**ADDENDUM 2**

**ADDENDUM DATE:** September 10, 2024

**PROJECT:** Rocky Mount Early Site Package  
400 Fountain School Rd  
Rocky Mount, NC 27801

COMPACTION REQUIREMENTS EXHIBIT

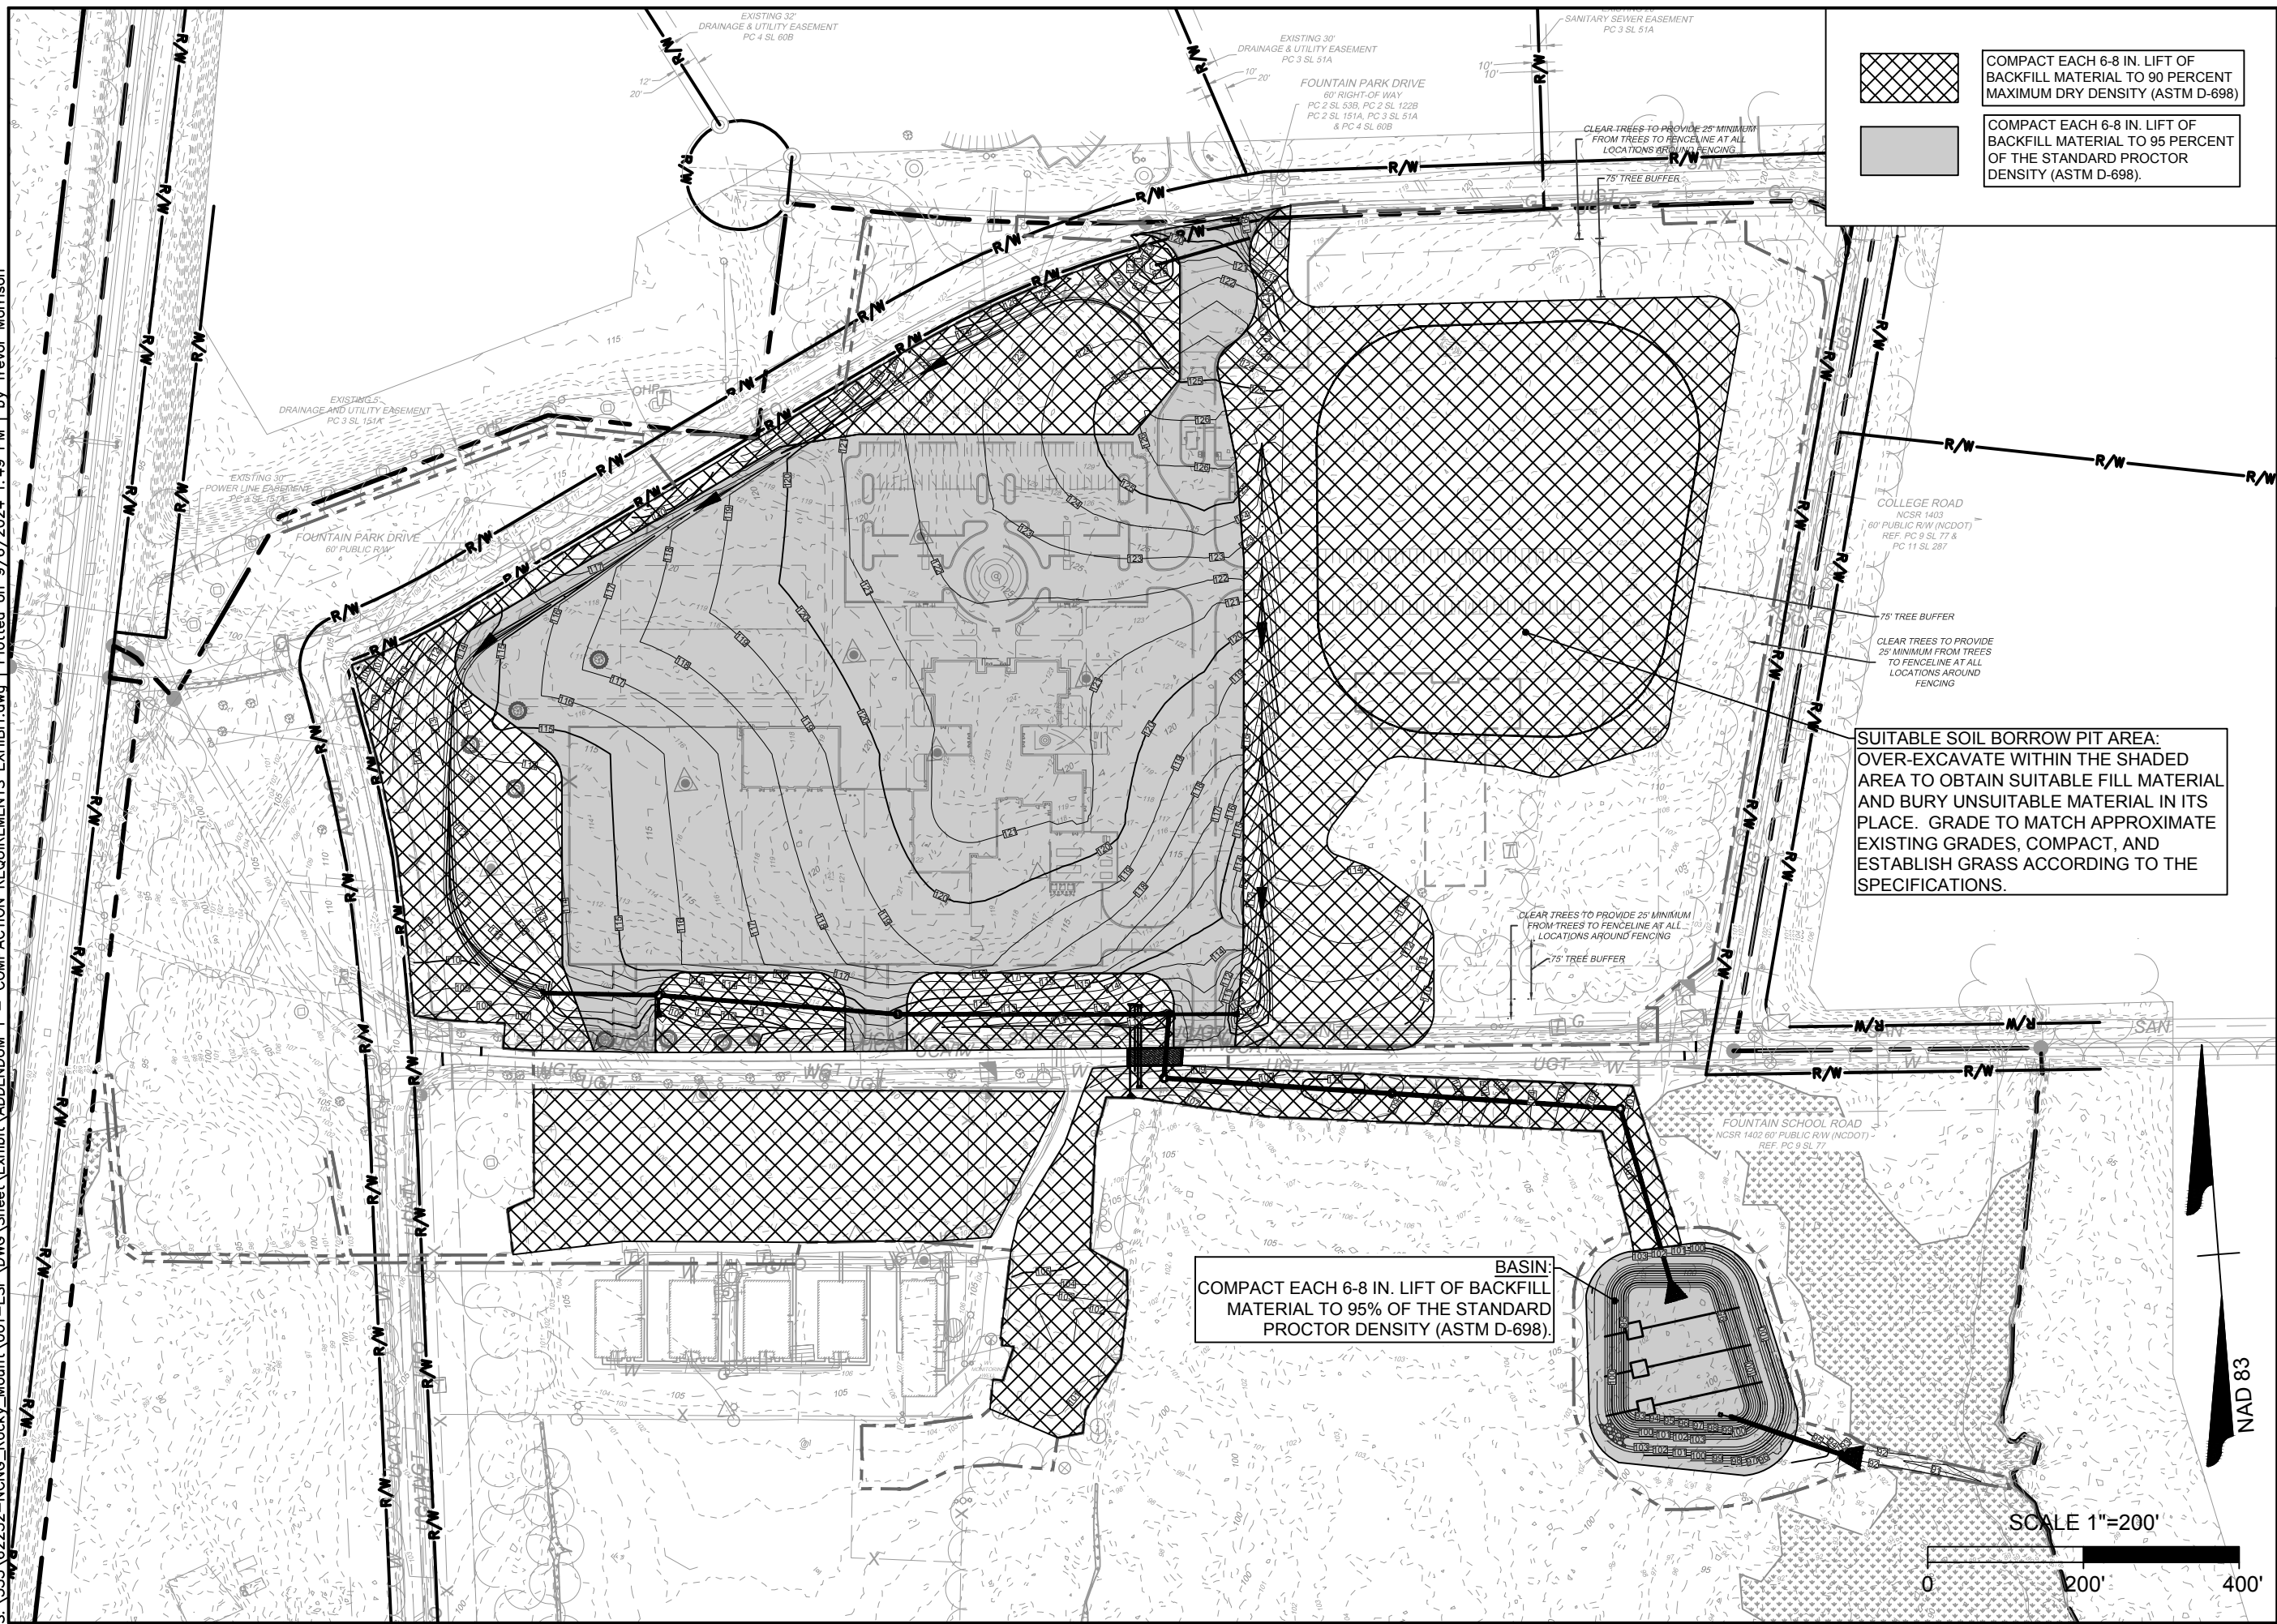
The required compactions for the various site areas are shown on the attached Compaction Requirements Exhibit sketch AD2-EX1.

COMPACT EACH 6-8 IN. LIFT OF BACKFILL MATERIAL TO 90 PERCENT MAXIMUM DRY DENSITY (ASTM D-698)  
 COMPACT EACH 6-8 IN. LIFT OF BACKFILL MATERIAL TO 95 PERCENT OF THE STANDARD PROCTOR DENSITY (ASTM D-698).
